Addendum # 2

April 24, 2018

St. Thomas Mission House Remodel
919 Indiana Ave.
Coeur d'Alene, Idaho 83814

From: Miller Stauffer Architects, PA.
601 E. Front Ave. Suite 201
Coeur d'Alene, ID 83814
Ph (208) 664-1773
Fax (208) 667-3174
Website: www.millerstauffer.com

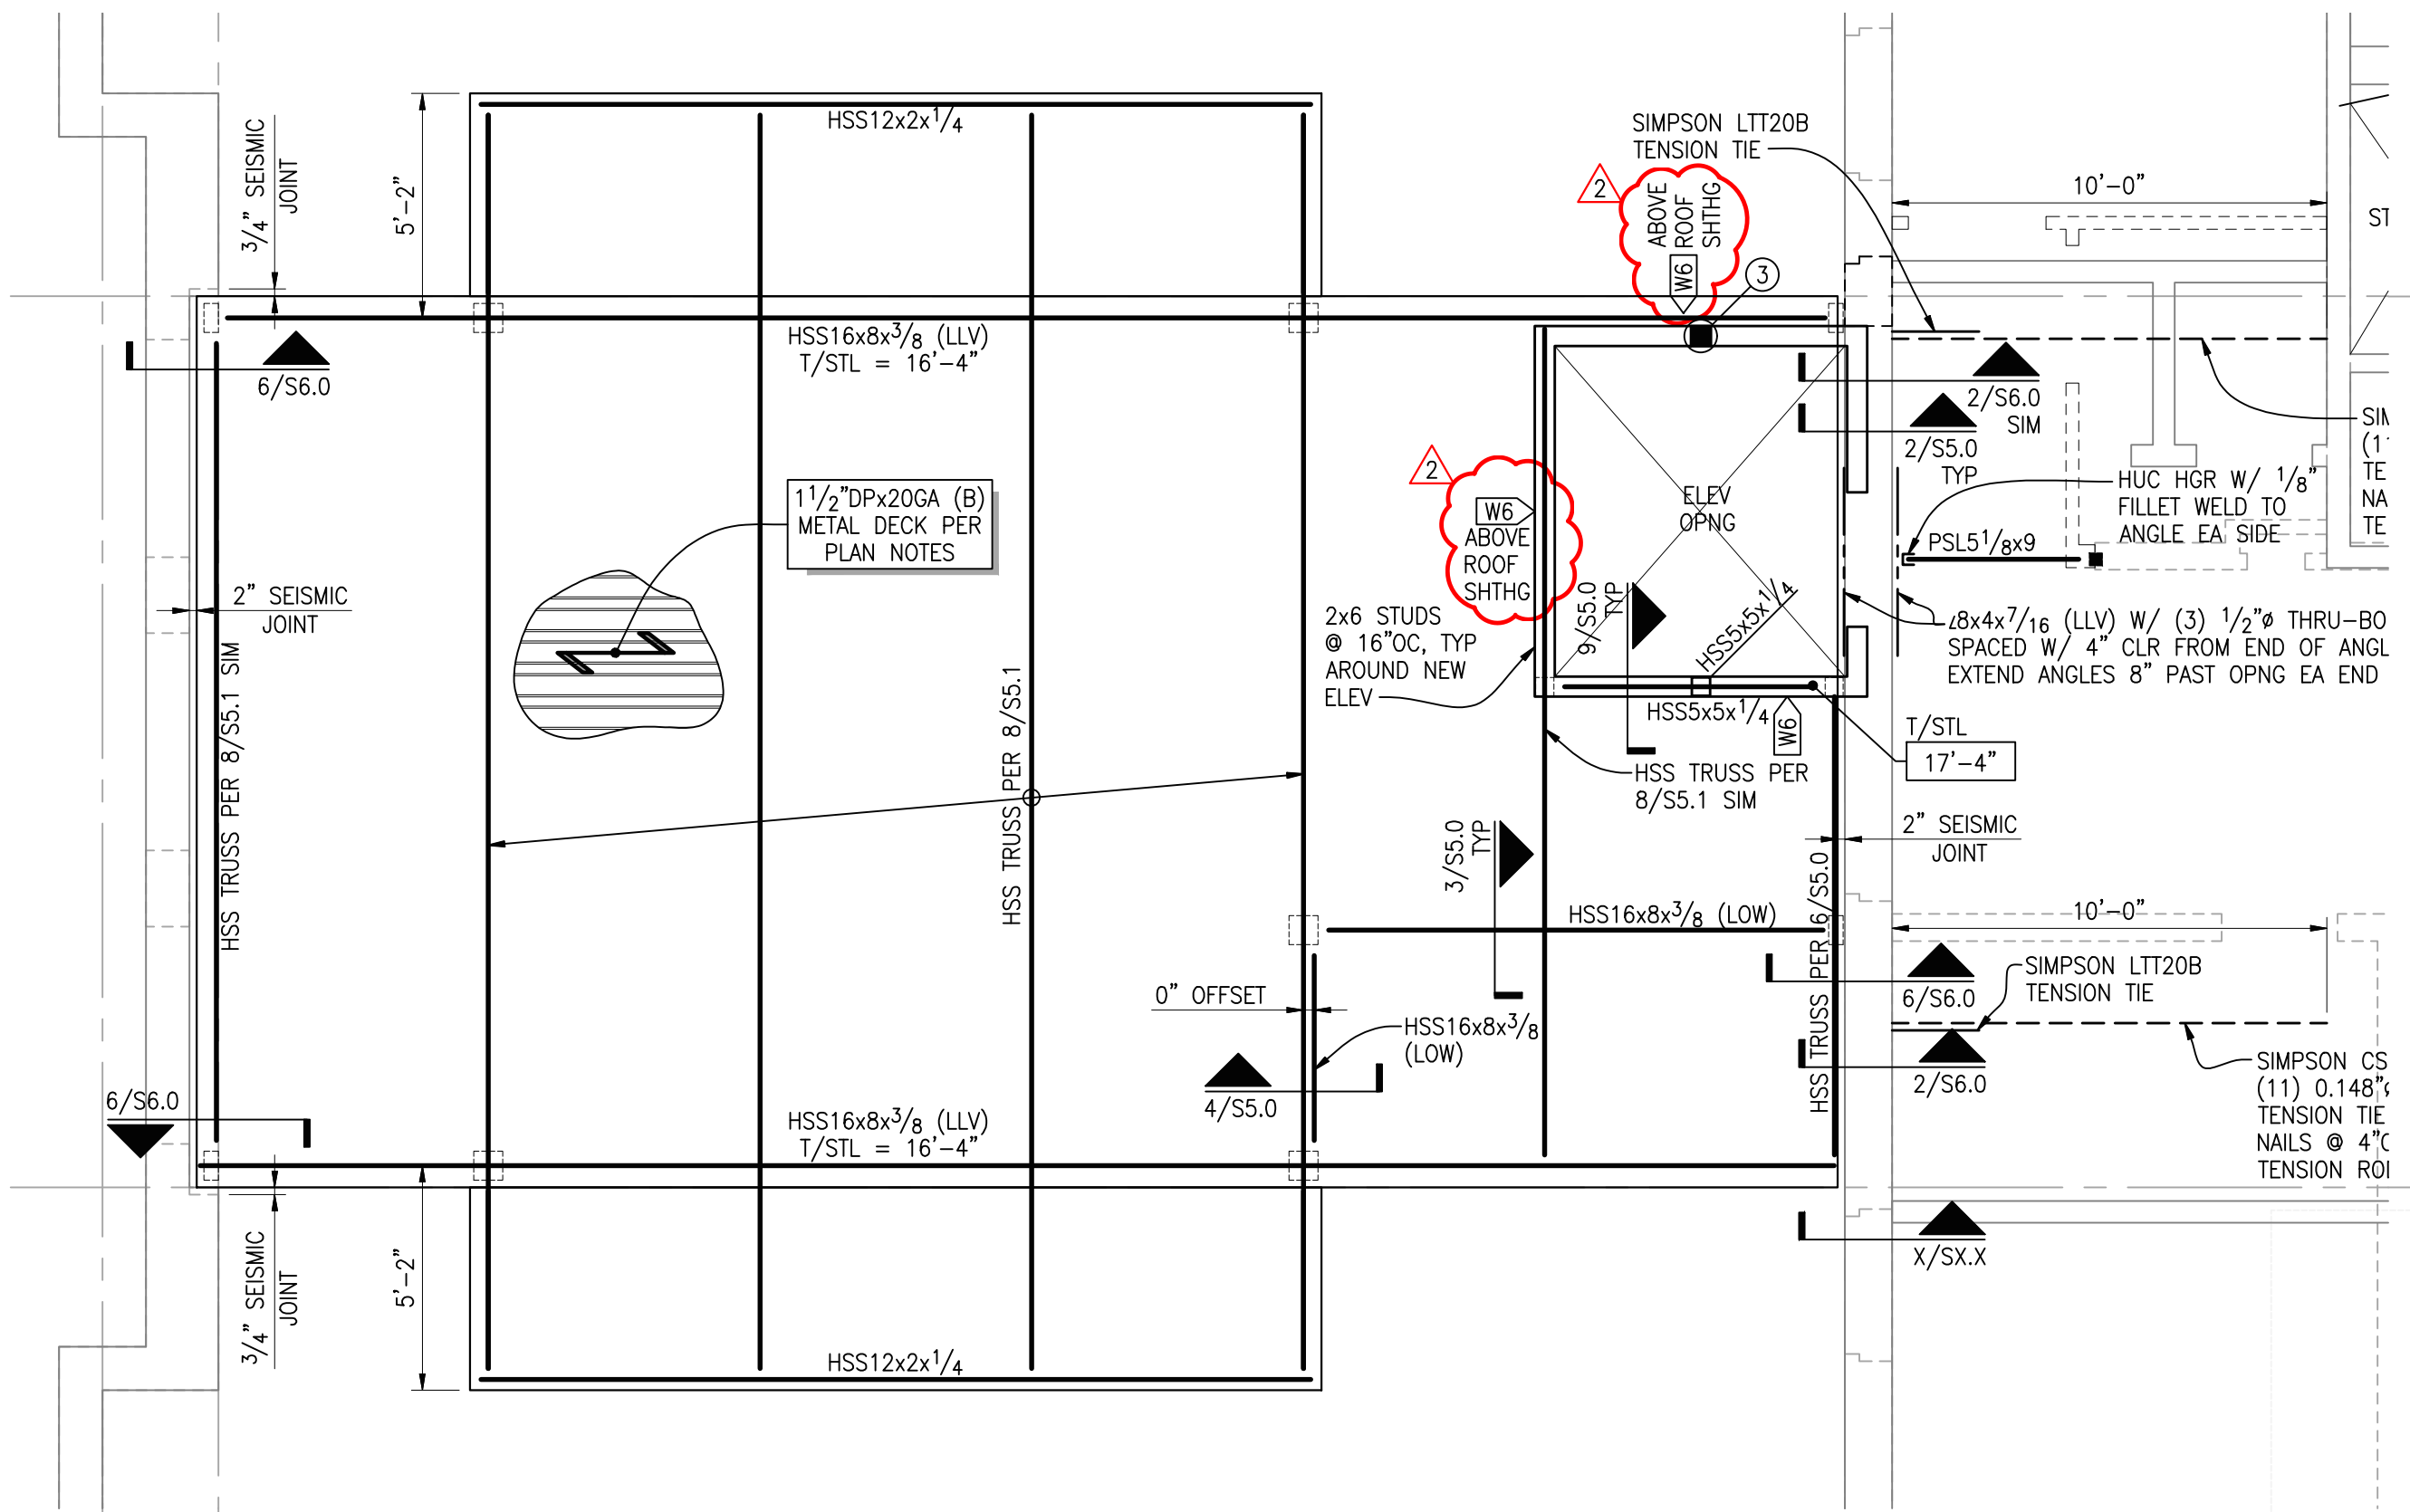
- A. S3.1 – Revised T/Conc wall elevations & column connections. Reference CS-01.
- B. S3.3 – Added note that shear wall applies only above roof. Reference CS-02.
- C. S4.1 – Added detail 6 & 10. Column connection to slab and stem wall. Reference CS-03 and CS-04.
